**DUKE POWER**

SUBJECT: Duke Power Company  
Request for Relief from ASME Boiler and Pressure  
Vessel Code, Section III Requirements  
Duke Power Request for Relief 95-GO-002  
Additional Information  
(TAC Nos. M92625, M92626, M92619, M92620)

McGuire Nuclear Station  
Docket Nos. 50-369, 370

Catawba Nuclear Station  
Docket Nos. 50-413, 414

CONFIGURATION 1  
RECYCLE HOLDUP TANKS

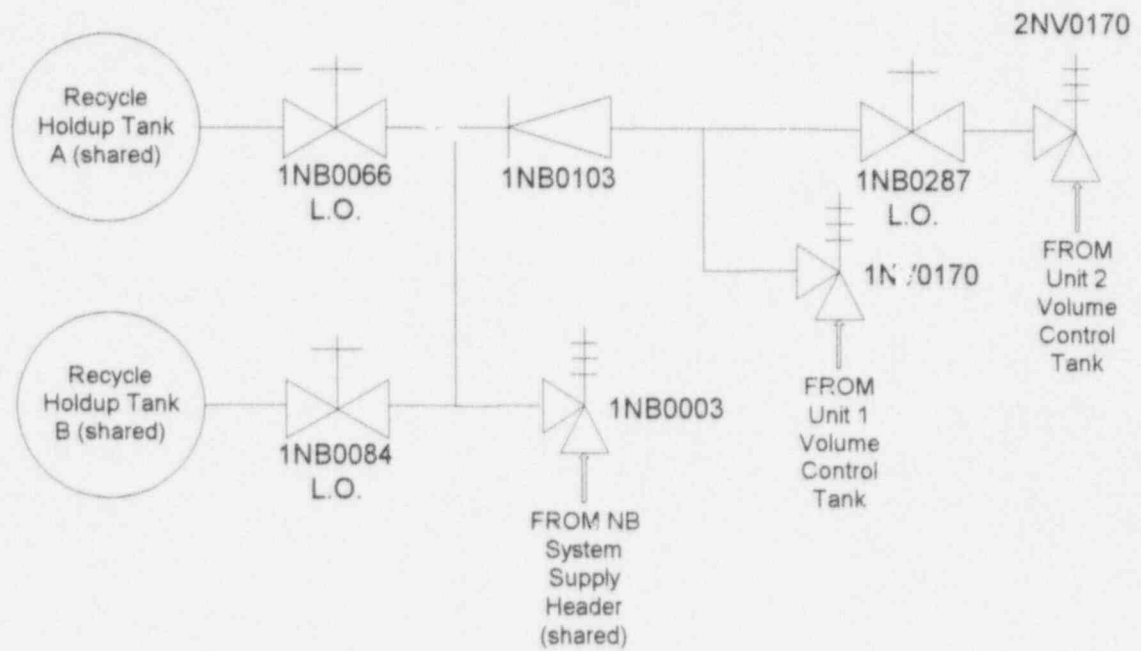
Relief previously requested for locked open block valves 1NB066 or 1NB084 is extended to include locked open block valve 1NB287 (See Configuration 1). Although shown in Figure 3 in the original 95-GO-002 Relief Request, locked open block valve 1NB287 was not specifically addressed in the June 15, 1995 letter. Relief valve 2NV170 provides pressure relief protection for the Unit 2 Volume Control Tank. It depends on locked open manual valve 1NB287 for a relief path to either Recycle Holdup Tank A or B (in addition to either of two locked open block valves 1NB066 or 1NB084 which were previously discussed in the relief request). Valve 1NB287 is an inter-unit isolation valve between McGuire Units 1 and 2 which is maintained in the locked open position.

Relief previously requested for locked open block valves 1NB066 or 1NB084 is extended to include the potentially blocked flow path for relief valve 1NB003 (See Configuration 1). Although shown in Figure 3 in the original 95-GO-002 Relief Request, relief valve 1NB003 was not specifically addressed in the June 15, 1995 letter. Relief valve 1NB003 provides pressure relief protection for the supply header to the Recycle Evaporator Feed Demineralizers. It depends on either of two locked open block valves 1NB066 or 1NB084 for a relief path to Recycle Holdup Tank A or B respectively. Both of these block valves were previously discussed in the relief request. The parallel arrangement of these valves allows maintenance isolation of either Recycle Holdup Tank without isolating the opposite tank and thus maintain a relief discharge path.

Procedure OP/0/A/6200/03 Enclosure 4.3 lists the normal position for Recycle Holdup Tank inlet block valves 1NB066 and 1NB084 as "locked open". In addition, procedure PT/1(2)/B/4700/23 Enclosure 13.4 requires these valves to be verified locked open semi-annually.

The parallel arrangement of these valves allows maintenance isolation of either Recycle Holdup Tank without isolating the opposite tank and thus maintain a relief discharge path. The alternate path would be available any time one valve might be closed for maintenance on the respective RHT. Therefore it is extremely unlikely that the relief header to at least one RHT would ever be unavailable when needed.

CONFIGURATION 2  
ECCS SUCTION AND DISCHARGE

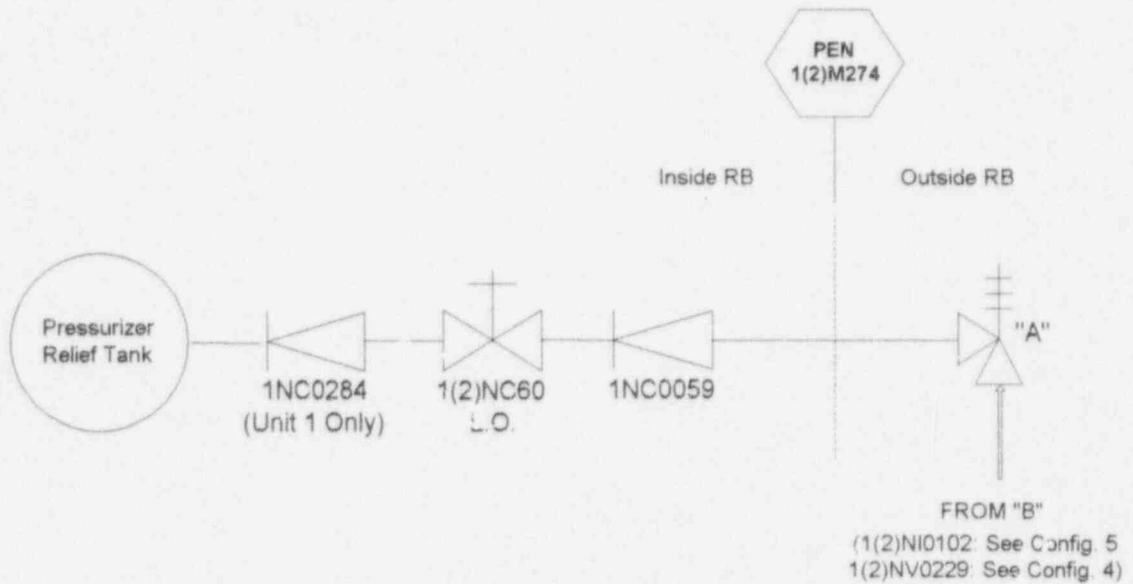
Relief is requested for locked open block valve 1(2)NC060 (See Configuration 2). The Emergency Core Cooling System suction and discharge relief valves discharge back into containment because of the potential for post accident coolant discharge. This includes the Safety Injection (NI) System, the Residual Heat Removal (ND) System, the Containment Spray (NS) System, and the Centrifugal Charging (NV) System. The outlet of ECCS Pressure Relief valves 1(2)ND056, 061, 064, 1(2)NI102, 119, 151, 161, 1(2)NS002, 019 and 1(2)NV229 depend on locked open manual valve 1(2)NC060 for an open relief path to the Pressurizer Relief Tank (PRT). The components protected by these relief valves are the NI and ND System Pumps and discharge piping to Reactor Coolant (NC) System Cold Legs, and Hot Legs and NI, ND, NS, and NV System suction headers. Valve 1(2)NC060 is maintained open except for maintenance isolation of the Pressurizer Relief Tank during No Mode when ECCS systems are not required to be operable. Relief valves 1(2)NI102 and 1(2)NV229 also have block valves on their inlet piping which is discussed later.

Procedure OP/1(2)/A/6150/04 Enclosure 4.8 lists the normal position for ECCS Relief Header to Pressurizer Relief Tank inlet block valves 1(2)NC060 as "locked open". In addition, procedure PT/1(2)/B/4700/24 Enclosure 13.1 requires these valves to be verified locked open at each cold shutdown since they are located inside containment.

Relief valves 1(2)ND056,061,064, 1(2)NI119,151, and 161 provide protection for the ND, and NI discharge headers which might be subjected to pressure higher than design pressure due to primary isolation valve (PIV) leakage. Relief valves 1(2)NI102, 1(2)NS002, 019 and 1(2)NV229 provide protection for NI, NS, and NV suction headers which might be subjected to pressure higher than design pressure due to either PIV leakage, leakby from interfacing systems, or pump discharge check valve leakage.

Each of these pressurization paths is subjected to periodic leakage testing to verify sufficient isolation capability of valves that isolate high/low pressure interfaces. The NI, and NV systems are also protected from overpressurization by normally open pump minimum flow paths that will divert pump discharge check valve leakage to the FWST or VCT. While the ND system minimum flow branches do not afford such protection, the ND System discharge and suction pressure is monitored during and following operation of the pumps (when check valve seat leakage could change). If pressurization occurs in such operation, action is taken to vent the system pressure and re-establish the differential pressure on the check valves.

CONFIGURATION 3  
SHUTDOWN TANKS

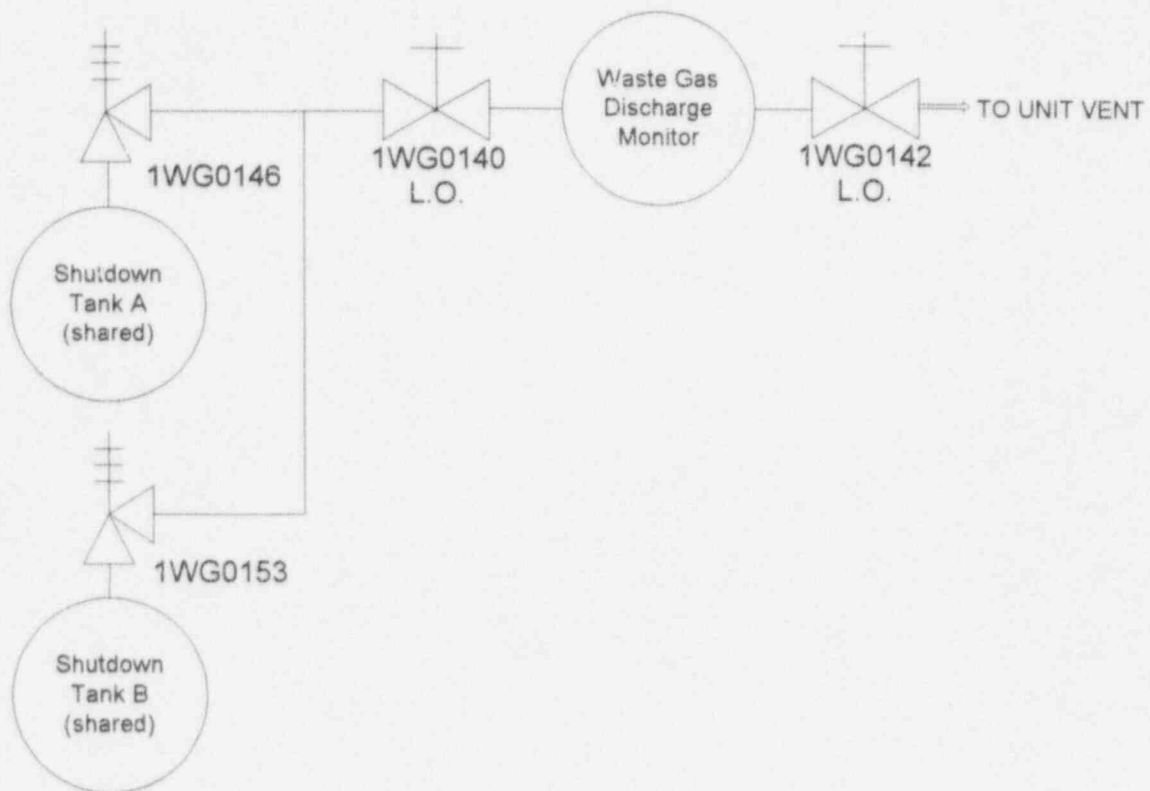
Relief is requested for locked open isolation valves 1WG140 and 1WG142 (See Configuration 3). Pressure Relief Valves 1WG146 and 1WG153 depend on locked open block valves 1WG140 and 1WG142 for an open relief path to the Unit Vent. Components protected by these relief valves includes the shared A and B Shutdown Tanks.

Procedure OP/0/B/6200/96 lists the normal position for the Waste Gas Discharge Monitor isolation valves 1WG140 and 1WG142 as "locked open". In addition, procedure PT/0/B/4700/19 requires these valves to be verified locked open periodically.

In addition to the administrative control for 1WG140 and 1WG142 (maintained locked open to assure WG system relief capability), the inherent design and operation of the WG system are sufficient to prevent an overpressurization event. The Shutdown Tanks are provided with high pressure alarms to provide warning of approach to relief valve setpoints. Shutdown Tank B is utilized infrequently during start-up and shutdown in support of primary degas operations. Only one Waste Gas Decay Tank (WGDT) or Shutdown Tank B can be in service at a time. The WGDTs individually relieve to Shutdown Tank A which is administratively maintained below 5 psig to ensure as adequate relief capacity for the inservice WGDT. If a WGDT relieved, Shutdown Tank A has suitable capacity to accommodate a single WGDT without lifting the relief valve on Shutdown Tank A. Therefore it is extremely unlikely that the relief header would ever discharge to the WG vent header.

CONFIGURATION 4  
 CA & NV PUMP SUCTION

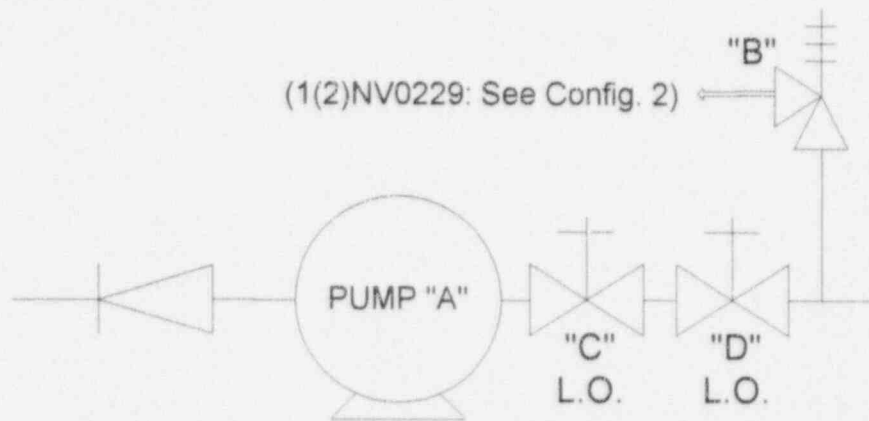
Relief is requested for locked open block valves 1CA025, 1CA030, 1CA019, 1(2)NV224, 1(2)NV230, 1(2)NV498 and 1(2)NV499 (See Configuration 4).

The Unit 1 Auxiliary Feedwater (CA) System pump suction pressure relief valves 1CA167, 168, and 128 depend on locked open manual valves 1CA025, 030, and 019 (respectively) for an open relief path to the atmosphere. These manual valves are maintained locked open except for system maintenance at which time the affected train is declared inoperable. The maintenance valve tagout includes closure of the pump discharge isolation valve to isolate the discharge line pressure sources and opening of a system vent to provide overpressure protection when the relief valve path is blocked. The components protected by these relief valves includes: Motor Driven Auxiliary Feedwater Pumps 1A and 1B and Turbine Driven Auxiliary Feedwater Pump 1 respectively. (The Unit 2 relief valves are on the pump side of the respective block valve and therefore comply with the Code.)

The inlet of NV System Pump suction pressure relief valve 1(2)NV229 depends on locked open manual block valves 1(2)NV224 and 1(2)NV498 for an open relief path to the PRT for providing relief protection for NV Pump 1(2)A. Similarly relief valve 1(2)NV229 depends on locked open manual block valves 1(2)NV230 and 1(2)NV499 for an open relief path to the PRT for providing relief protection for NV Pump 1(2)B. These manual valves are maintained locked open except for maintenance at which time the affected train is declared inoperable. The maintenance valve tagout includes closure of the pump discharge isolation valve to isolate the discharge line pressure sources and opening of a system vent to provide overpressure protection when the relief valve path is blocked.

Procedure OP/1/A/6250/02 Enclosure 4.8 lists the normal position for CA Pump suction block valves 1CA019, 1CA025 and 1CA030 as "locked open". It also gives a limit and precaution to verify the appropriate recirculation valve opens prior to stopping a CA Pump to ensure suction piping is not overpressurized when stopping a pump. Procedures OP/1(2)/A/6200/01 Enclosure 4.16 list the normal position for NV Pump suction block valves 1(2)NV224, 230, 498, and 499 as "locked open". In addition, procedures PT/1(2)/B/4700/23 Enclosure 13.4 requires the position of these (CA & NV Pump suction block) valves to be verified semi-annually.

The only time these pumps are isolated from their respective suction relief valve is during maintenance on the affected pump. Since the pump discharge is isolated and a vent on the affected pump is opened as part of the valve tagout for such maintenance, the operator aligning

CONFIGURATION 5  
 ND & NI PUMP SUCTION

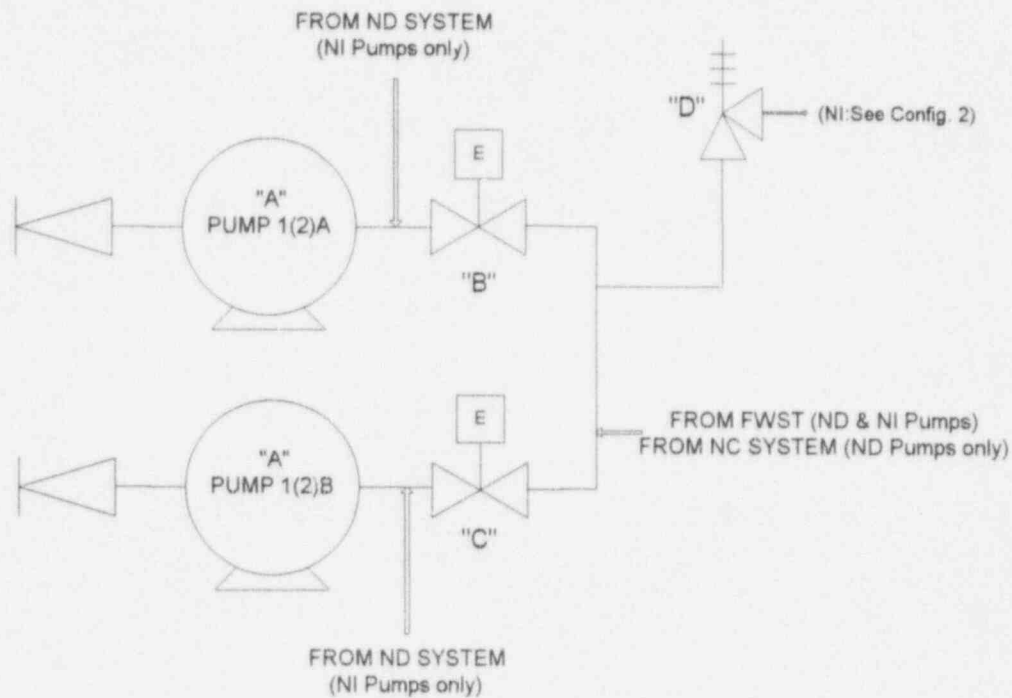
Relief is requested for normally open system isolation valves 1(2)ND004B, 1(2)ND019A, 1(2)NI103A, and 1(2)NI135B (See Configuration 5).

The inlet of NI System Pump suction pressure relief valve 1(2)NI102 depends on normally open motor operated valves 1(2)NI103A for an open relief path to the PRT for 1(2)A NI Pump. Similarly relief valve 1(2)NI102 depends on motor operated valve 1(2)NI135B for an open relief path to the PRT for providing relief protection for 1(2)B NI Pump. The normally open recirculation valves for each pump also provide relief protection for discharge check valve leakage. These motor operated valves are normally maintained open except for maintenance at which time the affected train is declared inoperable. The maintenance valve tagout includes closure of the pump discharge isolation valve to isolate the discharge line pressure sources and opening of a system vent to provide overpressure protection when the relief valve path is blocked.

The inlet of ND System Pump suction pressure relief valve 1(2)ND003 depends on normally open motor operated valve 1(2)ND019A for an open relief path to the PRT for providing relief protection for 1(2)A ND Pump. Similarly relief valve 1(2)ND003 depends on normally open motor operated valve 1(2)ND004B for an open relief path to the PRT for providing relief protection for 1(2)B ND Pump. These motor operated valves are normally maintained open except for maintenance at which time the affected train is declared inoperable. The maintenance valve tagout includes closure of the pump discharge isolation valve to isolate the discharge line pressure sources and opening of a system vent to provide overpressure protection when the relief valve path is blocked.

Procedures OP/1(2)/A/6200/04 Enclosure 4.11 list the normal position for ND Pump suction isolation valves 1(2)ND004B and 1(2)ND019A as "open". Procedures OP/1(2)/A/6200/06 Enclosure 4.1 list the normal position for NI Pump suction isolation valves 1(2)NI103A, and 1(2)NI135B as "open". In addition, each of these valves is included in the NRC Reg. Guide 1.47 alarm panel which gives a visual and audible alarm whenever these valves are closed. Since these valves do not receive an open (safety injection) signal, the associated pumps are considered to be out of service any time the associated suction valve is closed. These valves must be capable of closing to provide train separation to maintain an operable train of ECCS for certain failures of the redundant train.

The system isolation valves on ND and NI pump suction are maintained open during normal operation so that both trains of each system will be available as required to perform their ECCS function. For short durations valves at a quarterly frequency 1(2)NI135B, 1(2)ND004B and 1(2)ND019A are stroke tested during normal operation since they only affect the associated train. It is highly unlikely that the pump suction would be overpressurized for the short duration that the suction valve would be closed for stroke testing. (1(2)NI103A is maintained open during Modes 1-3 to provide B train ECCS recirc to the NV system.) Also as mentioned in the ECCS section above, the NI pump minimum flow path would provide a pressure relief path for the short time 1(2)NI135B might be closed.

For longer out of service durations these pumps are isolated from their respective suction relief valve, the pump discharge is isolated and a vent on the affected pump is established as part of the valve tagout. The operator aligning valves for the maintenance would observe any excessive or continuing vent flow and would take appropriate action to avert any situation which might lead to an overpressure event.

### CONFIGURATION 6 REACTOR BUILDING KC DRAIN HEADER

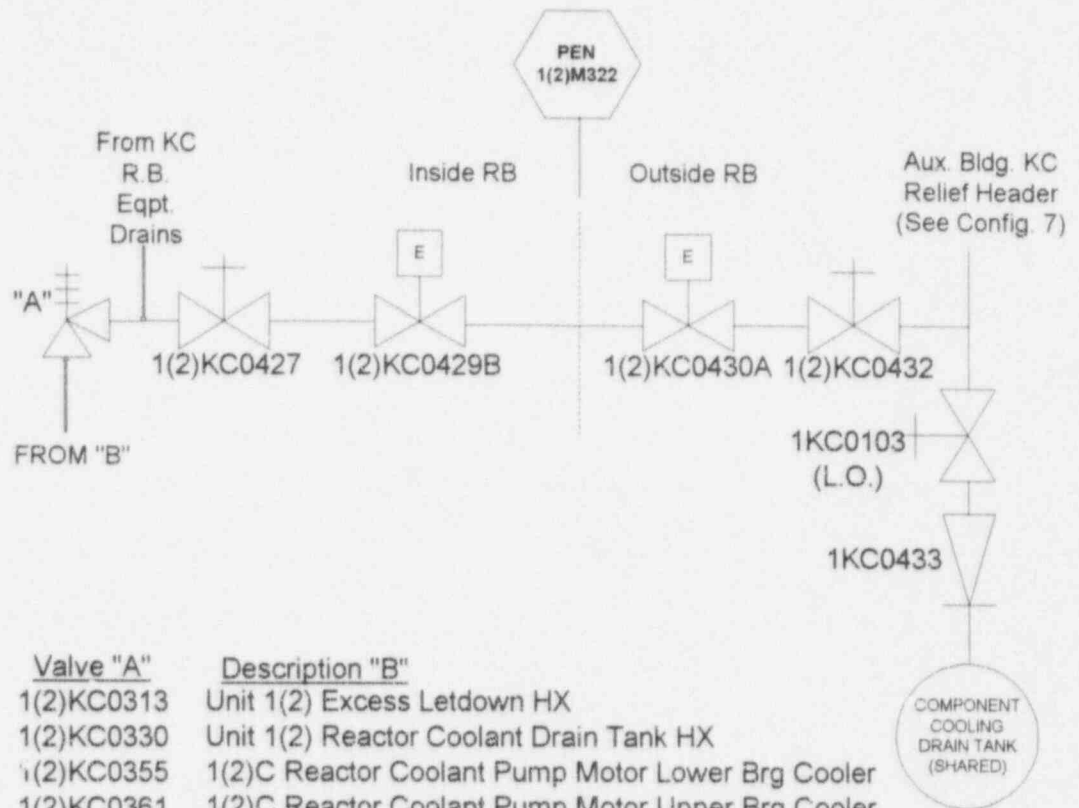
(Configuration 6) - The Component Cooling System thermal relief valves located inside the Reactor Building are subject to containment isolation which would close valves 1(2)KC429B and 1(2)KC430A and isolate all of the relief valve discharges from the KC Drain Tank. The relief valve discharges also depend on normally open manual valves 1(2)KC427, 1(2)KC432 and locked open manual valve 1KC103 for an open relief path to the tank. This includes the following relief valves: 1(2)KC313, 330, 355, 361, 374, 380, 386, 392, 404, 410, 490, 491, 492, and 493. The components protected by these thermal relief valves includes: 1(2)Excess Letdown and 1(2) Reactor Coolant Drain Tank Heat Exchangers, 1(2)A(B,C,D)Reactor Coolant Pump Motor Upper and Lower Bearing Coolers, and 1(2)A(B,C,D)1(2) Reactor Vessel Support Coolers.

Procedure OP/1/A/6400/05A Enclosure 4.3 lists the normal position for Component Cooling Drain Tank inlet block valves 1KC103 as "locked open". In addition, procedure PT/1(2)/B/4700/23 Enclosure 13.4 requires this valve to be verified locked open semi-annually. Procedures OP/1(2)/A/6400/05A Enclosures 4.1 and 4.2 list the normal position for containment isolation valves 1(2)KC429B and 1(2)KC430A and block valves 1(2)KC427 and 1(2)KC432 as "open" and flow control valves 1(2)KC149 and 1(2)KC156 as "throttled".

Although a considerable list of equipment is included in the KC system relief valves that potentially can be isolated, the relief discharge volume from thermal expansion is considered to be an insignificant volume compared to the available gas volume expected to reside in these drain headers since they are not vented to remove air. Heat exchangers needed to perform post accident functions (i.e. Residual Heat Removal Heat Exchangers) would not be expected to be isolated and thus would not require thermal relief. In service Fuel Pool Heat Exchangers likewise would not be isolated except for maintenance at which time a vent on the affected heat exchanger or cooler is established as part of the valve tagout. The operator aligning valves for the maintenance would observe any excessive or continuing vent flow and would take appropriate action to avert any situation which might lead to an overpressure event.

### CONFIGURATION 7 AUXILIARY BUILDING KC DRAIN HEADER

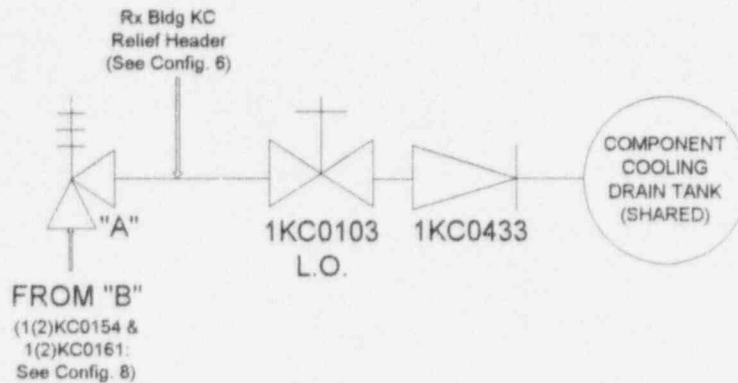
(Configuration 7) - The Component Cooling System thermal relief valves located outside the Reactor Building depend on locked open manual valve 1KC103 for an open relief path to the shared KC Drain Tank. This includes the following relief valves: 1(2)KC061, 079, 086, 104, 138, 147, 154, 161, 187, 193, 199, 205, 211, 217, 223, and 1KC170, 234, 241, 248, 261, 268, 275, 458, 461, and 472. The components protected by these thermal relief valves includes: 1(2)A(B) Residual Heat Removal and Fuel Pool Heat Exchangers, 1(2) Letdown and Seal Water Heat Exchangers, 1(2)A(B,C,D) Steam Generator Blowdown Sample Heat Exchangers, 1(2) Pressurizer, Residual Heat Removal Loop, and Reactor Coolant Hot Leg Sample Heat Exchangers, 1A(B) Waste Gas Compressor and Waste Gas Hydrogen Recombiner Heat Exchangers, Waste, and Recycle Evaporator Condensers, and Distillate Coolers, and Waste, and Recycle Evaporator Vent Condensers.

### CONFIGURATION 3 FUEL POOL HEAT EXCHANGERS

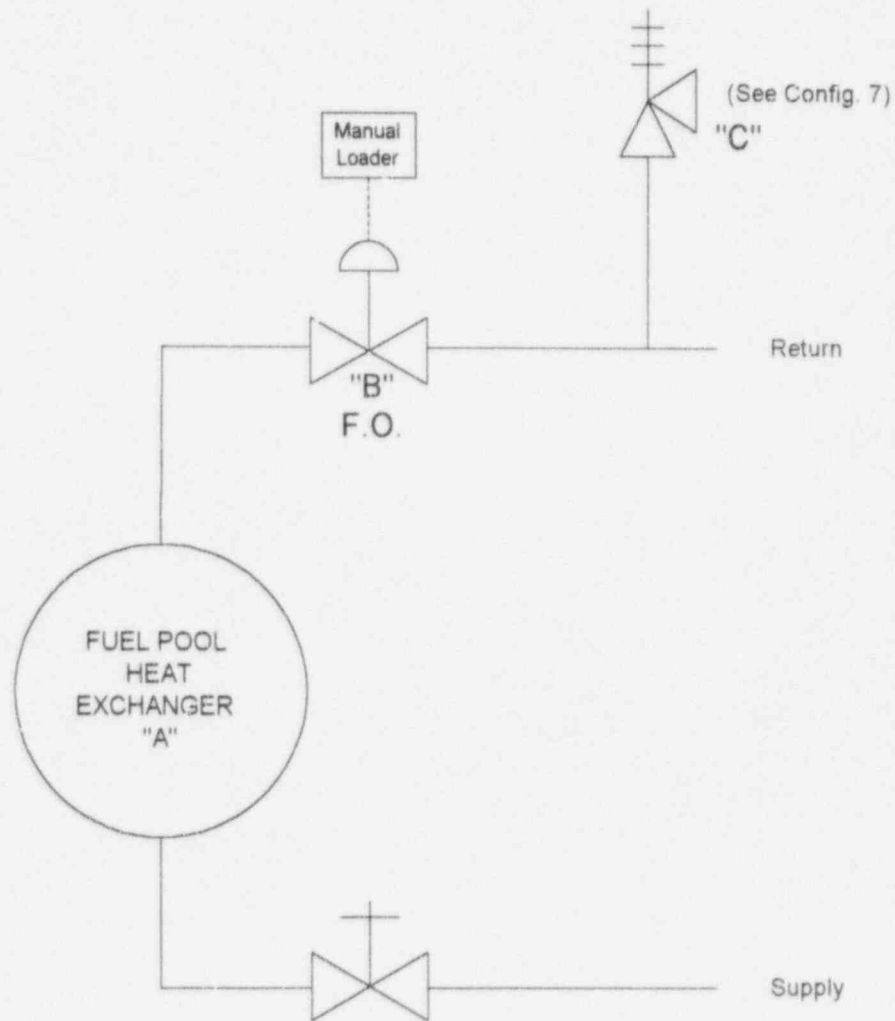
(Configuration 8) - The Fuel Pool Heat Exchanger A and B thermal relief valves depend on normally open (Fail Open) air operated control valves 1(2)KC149 and 1(2)KC156 for an open relief path to the shared KC Drain Tank. Any time the KF (Fuel Pool Cooling) system is aligned to the heat exchanger, these valves are maintained at least partially open to provide cooling for the heat load maintained by these heat exchangers except for maintenance at which time the affected train is declared inoperable. The maintenance valve tagout includes closure of the heat exchanger inlet isolation valve to isolate the discharge line pressure sources and opening of a system vent to provide overpressure protection when the relief valve path is blocked.
